DESIGN <i>[Signature]</i>	DRAWN BY <i>CP</i>	DART AEROSPACE LTD HAWKESBURY, ONTARIO, CANADA	
CHECKED <i>[Signature]</i>	APPROVED <i>[Signature]</i>	DRAWING NO. DSI 9263	REV. A SHEET 1 OF 1
DATE 03.06.25		TITLE SPACER BLOCK KIT	SCALE NTS
A	03.06.25	NEW ISSUE

DART SERVICE INSTRUCTION

TO AMEND INSTALLATION INSTRUCTIONS IIN-D206-667 REV. A or B

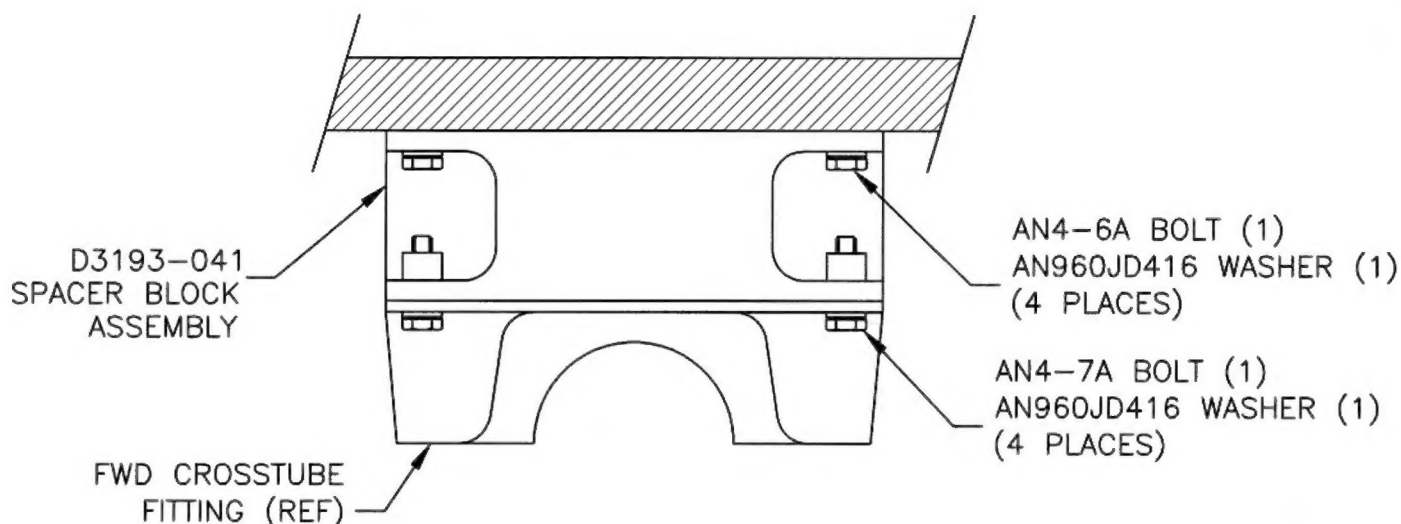
WHEN CONVERTING A 206 A/B AIRCRAFT FROM LOW TO HIGH GEAR BY INSTALLING D206-681-011 LANDING GEAR, THE D206-667-011 SPACER BLOCK KIT (OR EQUIVALENT) MUST BE INSTALLED BETWEEN THE FUSELAGE AND FWD CROSSTUBE FITTINGS BEFORE INSTALLING THE LANDING GEAR ON THE AIRCRAFT.

QTY -011	Part Number	Description
X	D206-667-011	SPACER BLOCK KIT
8	AN4-6A	BOLT
8	AN4-7A	BOLT
16	AN960JD416	WASHER
2	*D3193-041	SPACER BLOCK ASSEMBLY

* OR AA P/N 206-321-005 OR BHT P/N 206-031-586-003
